Burlington Design Advisory Board

DESIGN ADVISORY BOARD Tuesday, December 27, 2022 3:00 PM

ZP-22-554; 31 Volz Street (RM, Ward 3C) Philip & Katherine Geraghty / Steve Guild

MEMORANDUM

SHEET TITLE:
EXTERIOR
ELEVATIONS

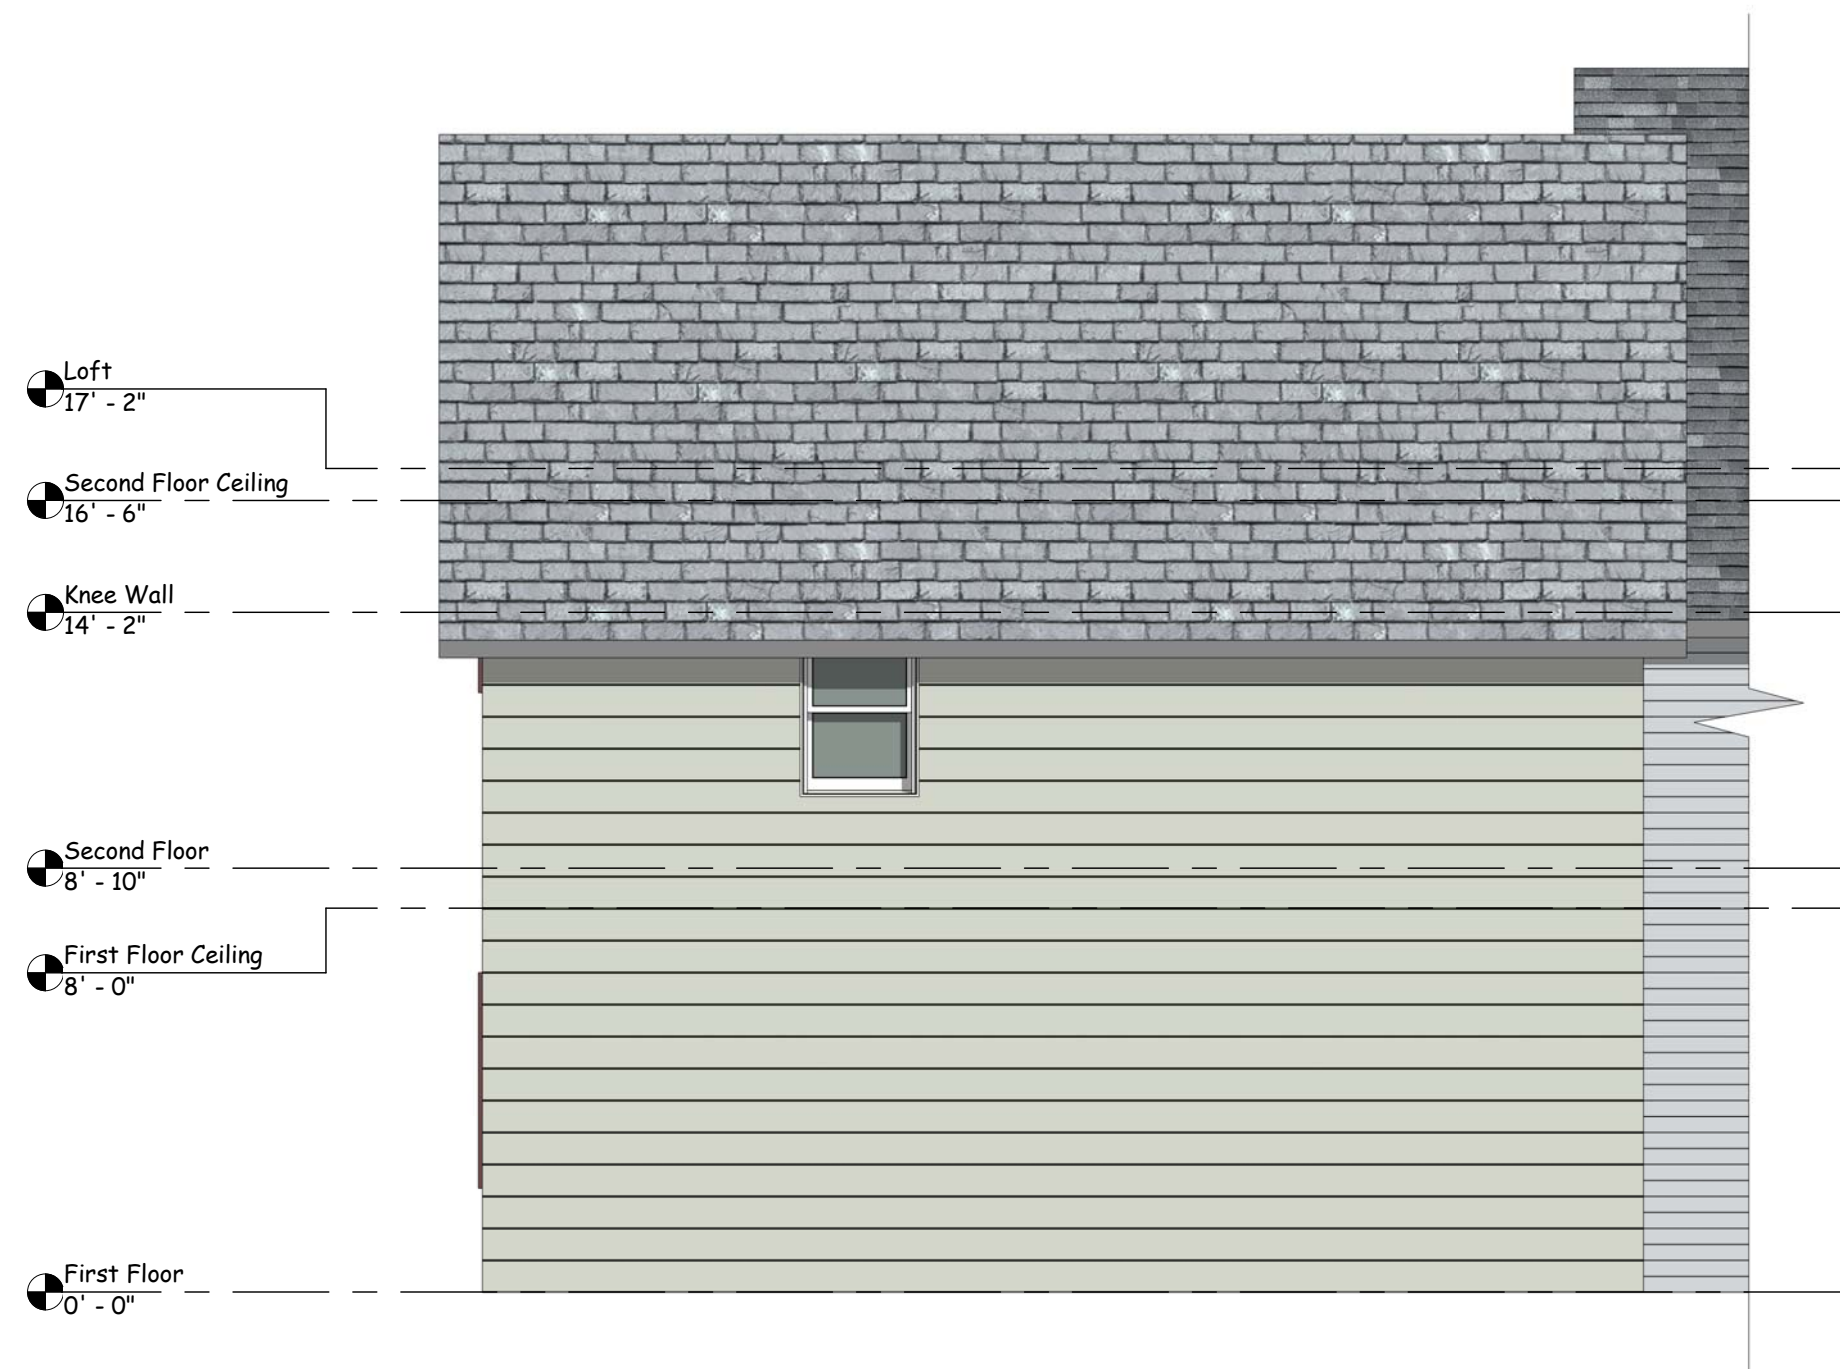
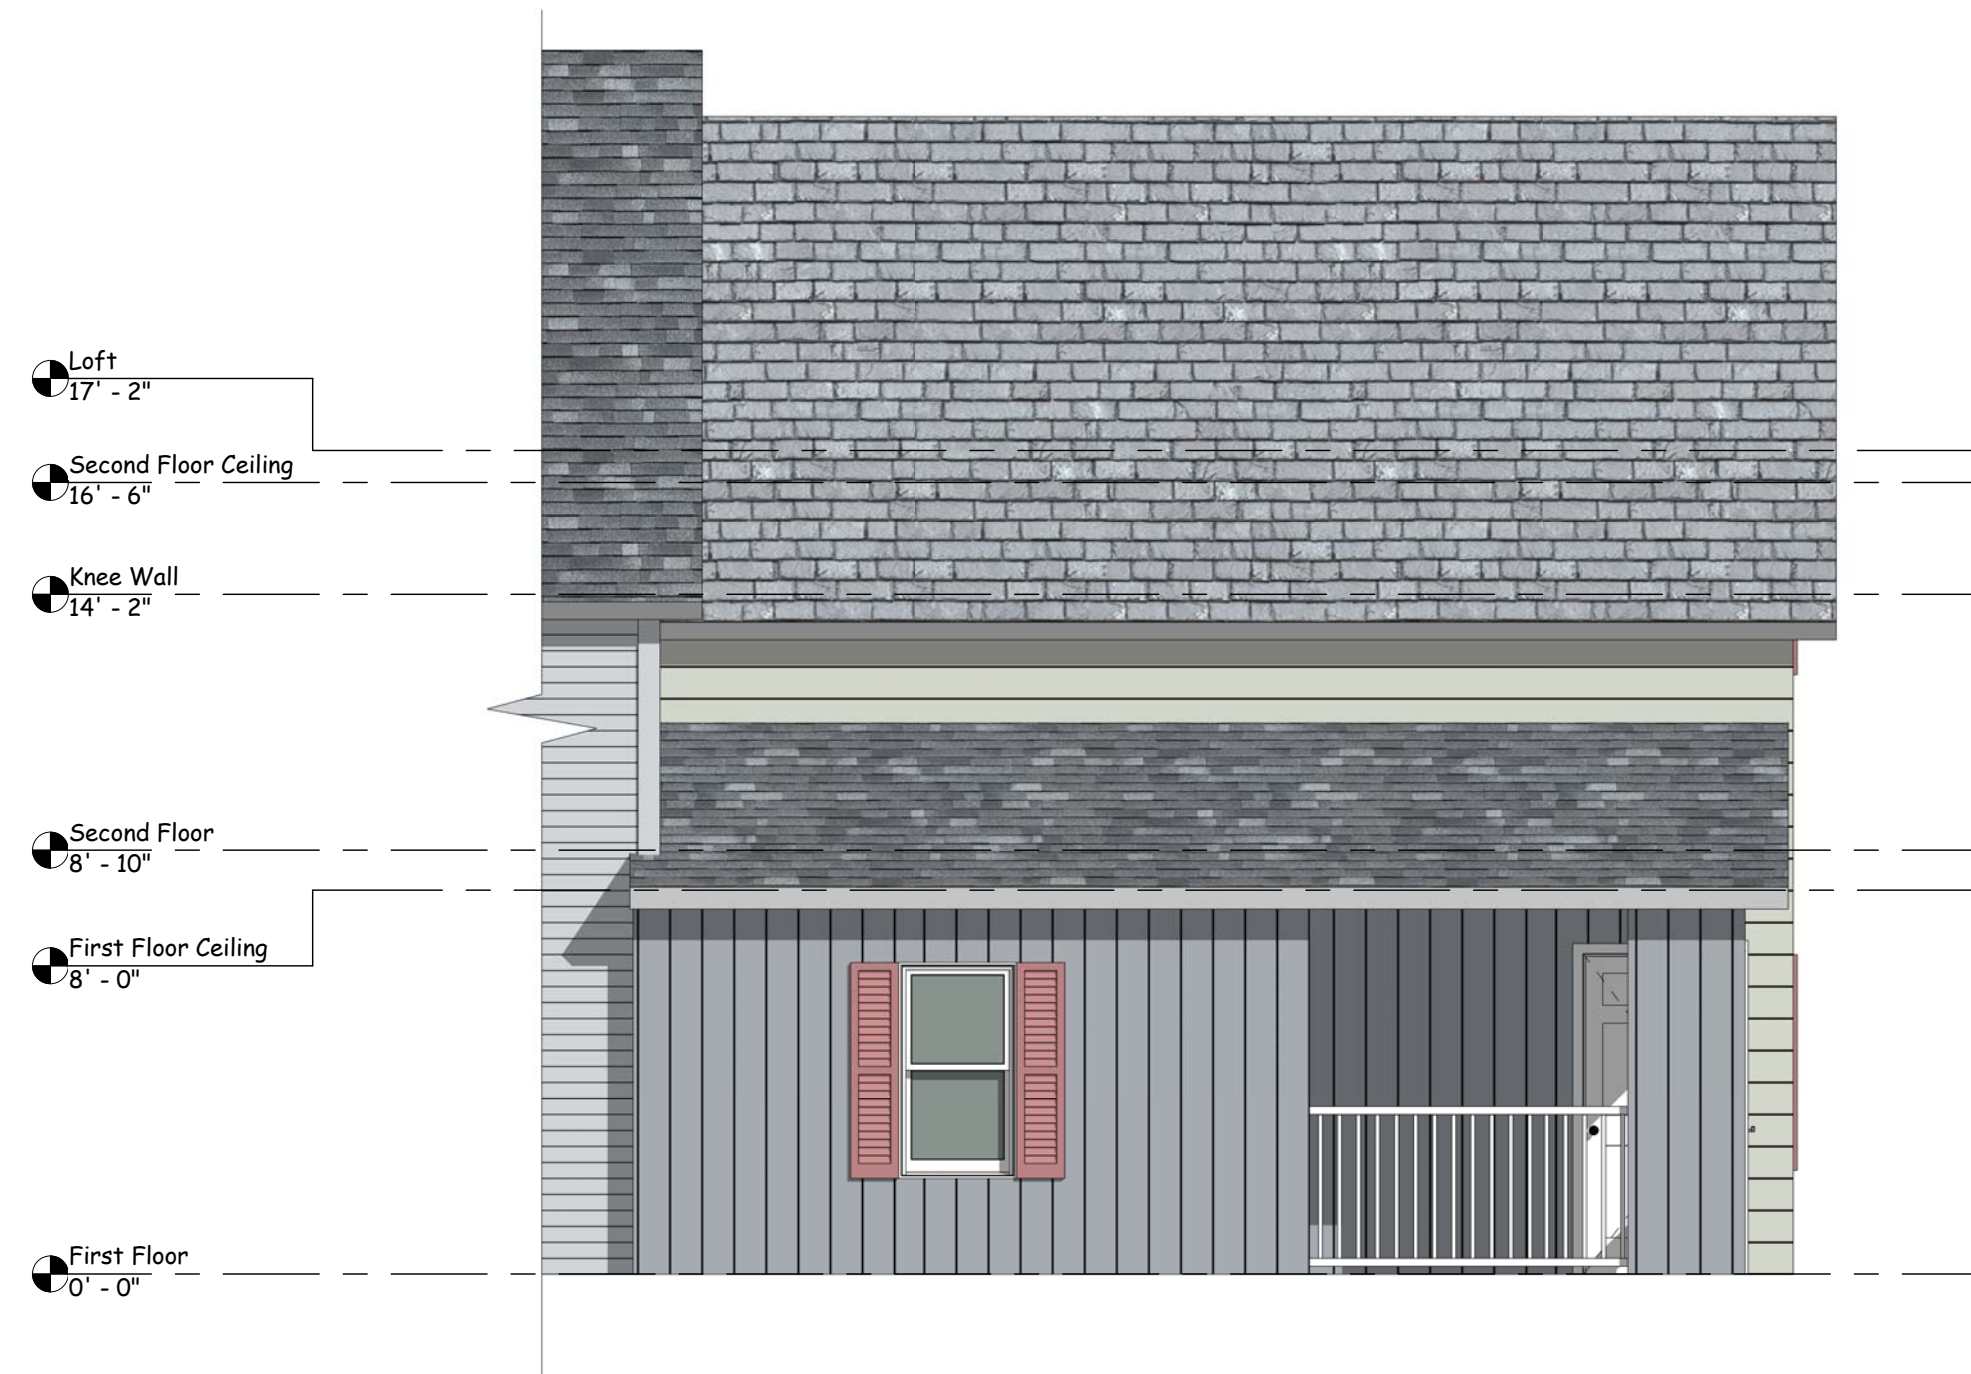
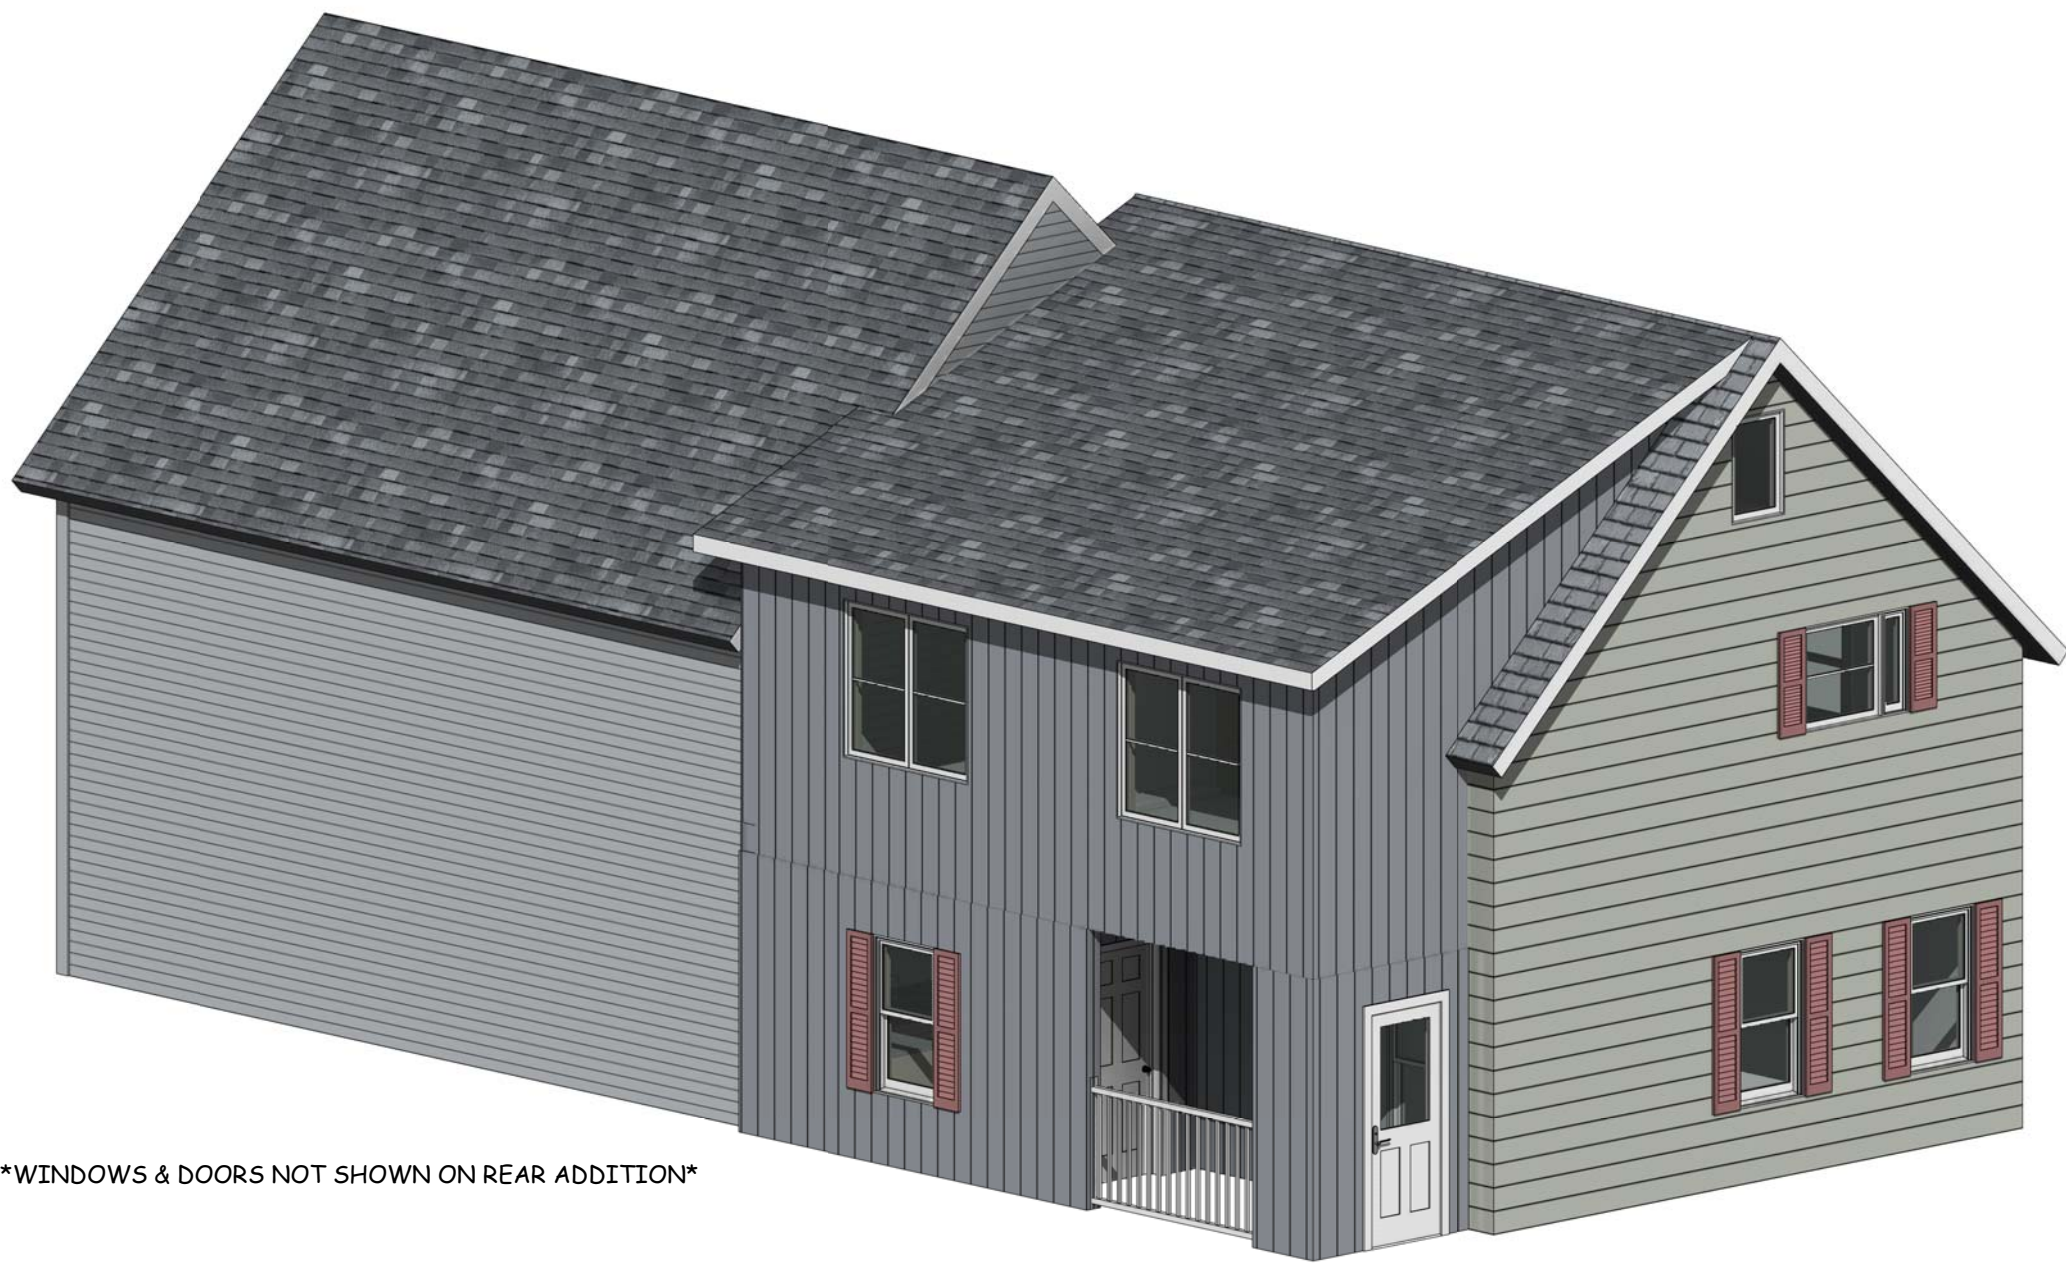
The “existing” building elevations are incorrect; the window on the west elevation has a deck with an exterior staircase (unpermitted, and within a required setback.) Although the application proposes removal of the deck/stairs, it never received permit review and approval.

EXTERIOR
ELEVATIONS

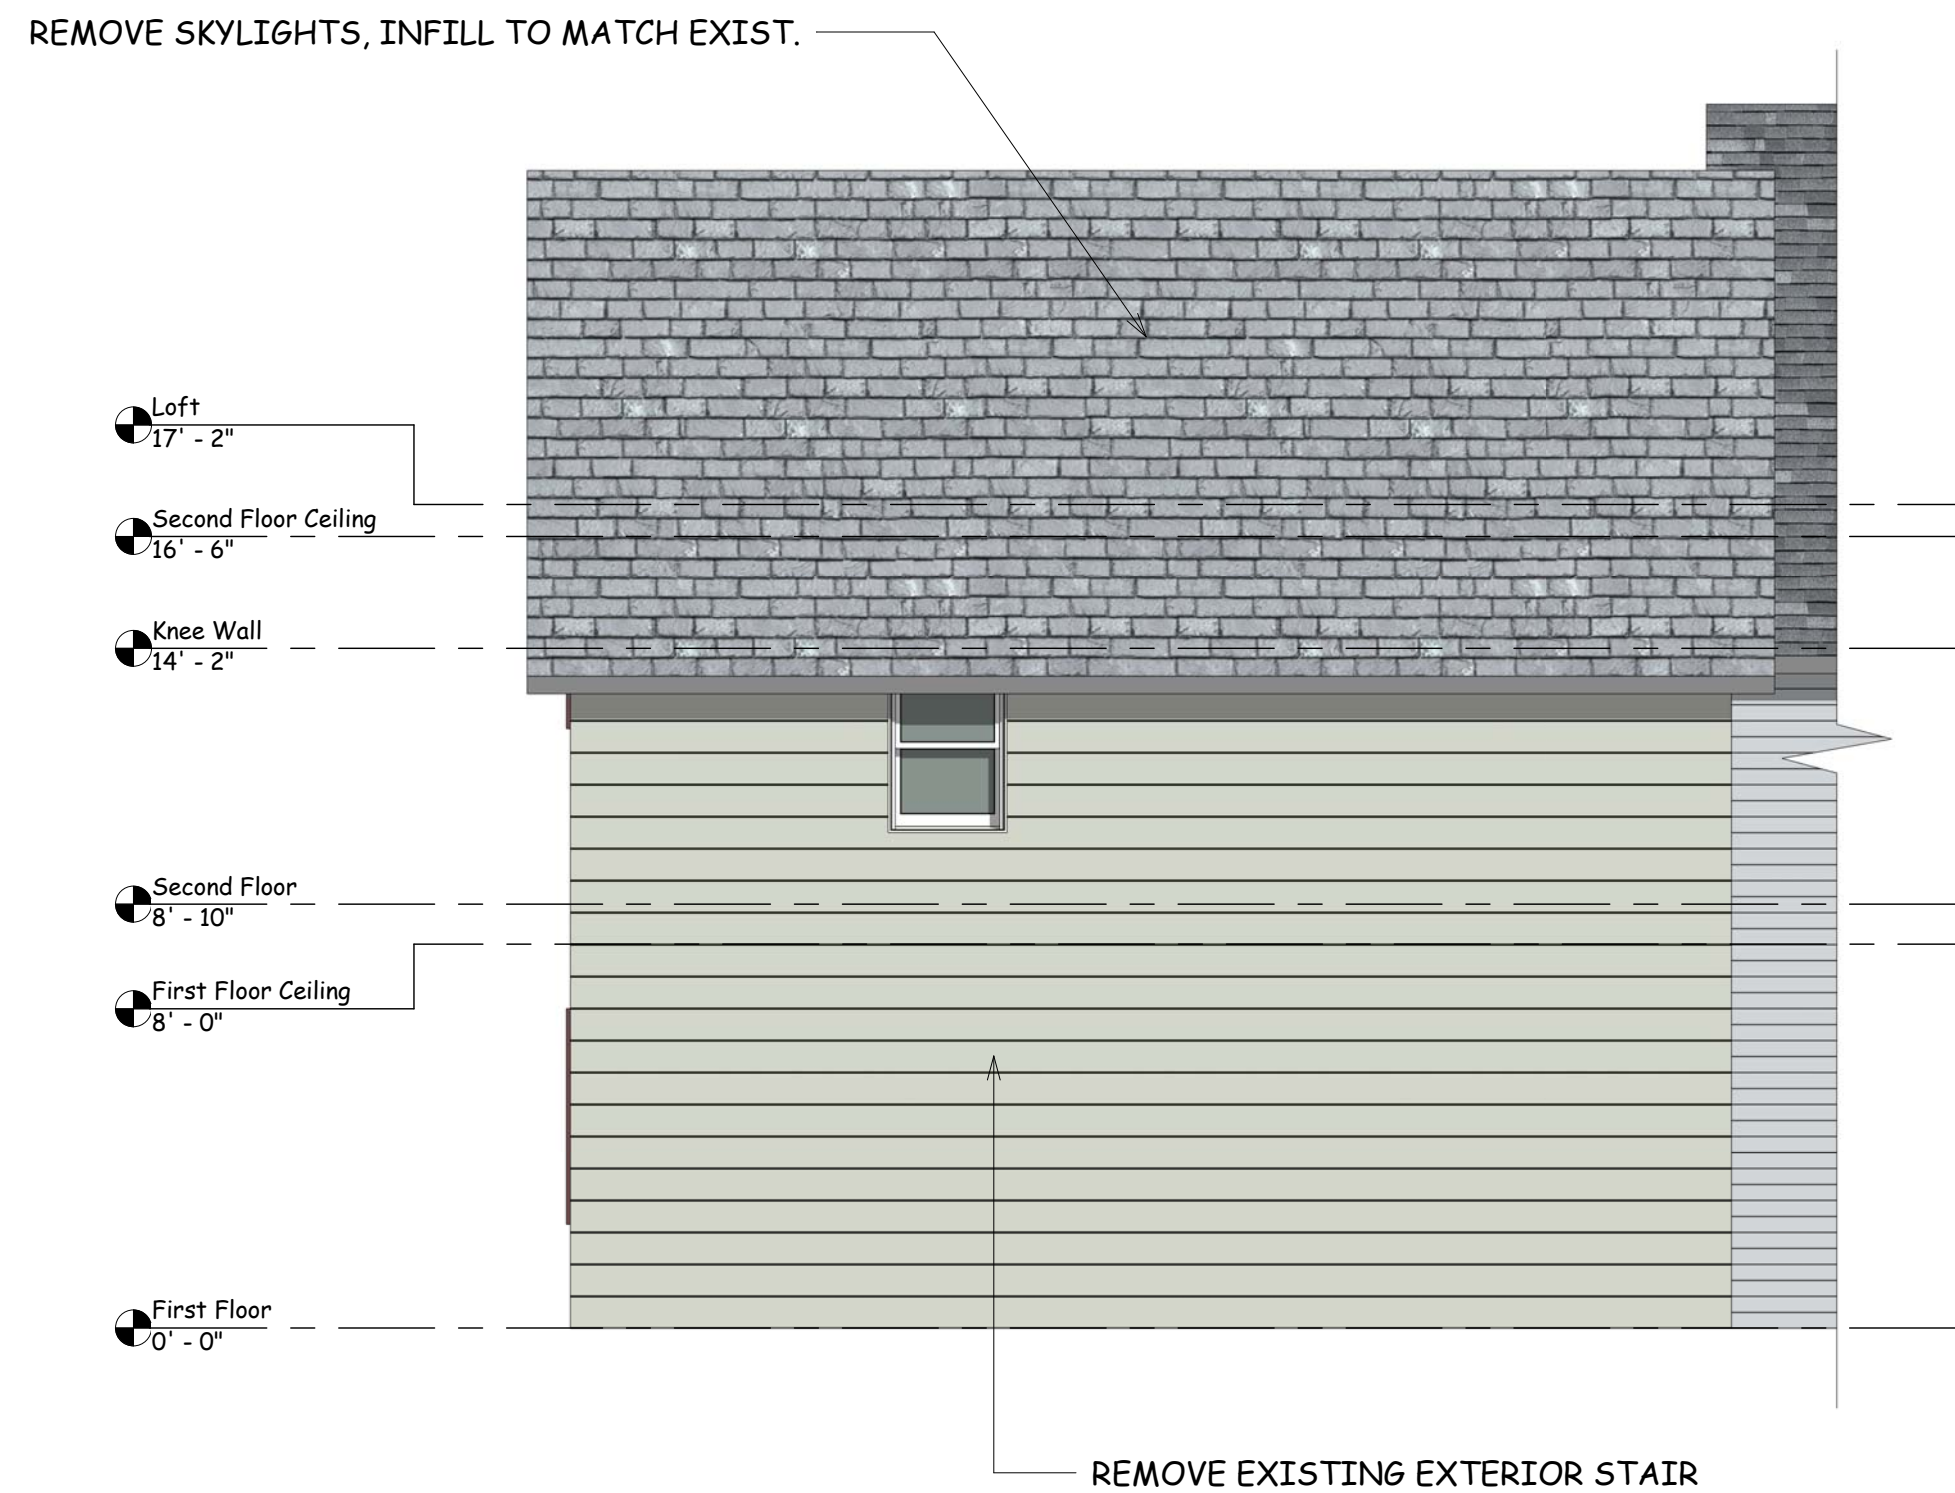
While nothing will be removed from the existing structure, the new dormer will attach to the existing roof, which is covered with patterned slate. It will almost entirely cover the historic slate roofing on the east side of the gable roof. A small portion of the slate roof on this side will remain where the dormer does not cover it. As a result, the existing east-side roof will be altered. The slate roofing on the west side of the gable roof will remain. The application refers to removal of skylights with slate infill. (See plan A-3).
